Access Compliance Report

Public Rights-of-Way (Curb Ramps)

Intersection ID: 54465	Main Street: RUPELL_DR	Cross Street: COLLINGHAM_DR	Location: SW
ADA ID: A2929B895DB2	Ramp Type: Perp	Initial Pass/Fail: Fail	Overall Compliance: No
		Severity Score: 1.25

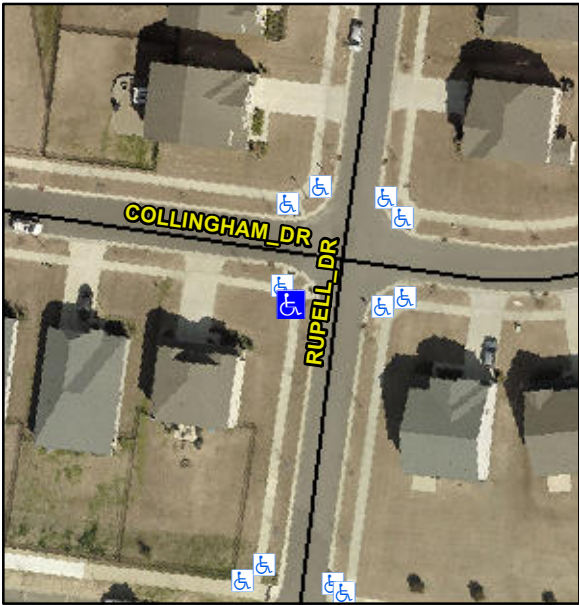
Codes/Mitigation Info/Possible Solution			Field Measurements/Component Compliance					
	Possible Solutions:		Compliance	Description	Data	Compliance	Description	Data
	Remove & Replace Entire Ramp.		N/A	Ramp Length (in)	105.0	Yes	Ramp Slope (%)	7.9
			Yes	Ramp Width (in)	48.0	No	Ramp XSlope (%)	3.0
			N/A	Flare Type LT	N/A	N/A	Flare Type RT	N/A
			N/A	Flare Slope LT (%)	N/A	N/A	Flare Slope RT (%)	N/A
			N/A	Flare Traversable LT?	N/A	N/A	Flare Traversable RT?	N/A
			N/A	Landing Length (in)	N/A	N/A	DWS Provided?	N/A
			N/A	Landing Width (in)	N/A	N/A	DWS Contrast?	N/A
			N/A	Landing Slope (%)	N/A	N/A	DWS Length (in)	N/A
			N/A	Landing X Slope (%)	N/A	N/A	DWS Full Width?	N/A
Surveyor Notes:		N/A	N/A	Landing Curb? (Y/N)	N/A	N/A	DWS Offset (in)	N/A
			N/A	Shared Landing?	N/A			
PROW/ADA:		Not Found, R304.5.3	N/A	Gutter Ponding?	N/A	N/A	Gutter Slope (%)	N/A
			N/A	Gutter Lip Ht (in)	1.0	N/A	Gutter X Slope (%)	N/A

N/A	Painted X Walk1?	No	N/A	Painted X Walk2?	N/A
				X Walk 1 Direction	To SE		X Walk 2 Direction	N/A
			N/A	X Walk 1 Width (in)	N/A	N/A	X Walk 2 Width (in)	N/A
				X Walk 1 Slope (%)	3.6		X Walk 2 Slope (%)	N/A
				X Walk 1 X Slope (%)	1.5		X Walk 2 X Slope (%)	N/A
Street 1 Name		RUPELL DR	N/A	Ramp inside XWalk1?	N/A	N/A	Ramp inside XWalk2?	N/A
Stop Condition-Street 2		StopSign		Road Slope (%)	N/A	N/A	Clear Space?	N/A
Street 2 Name		N/A		Road X Slope (%)	N/A	N/A	Clear Space to XWalk (in)	N/A
Stop Condition-Street 1		N/A	N/A	Any Obstructions?	N/A	N/A	Storm Grate/Utility Hazard?	N/A
				Obstruction Type			Storm Grate/Utility Type	
					N/A			N/A
						Yes	Surface Condition? (G/P)	Good
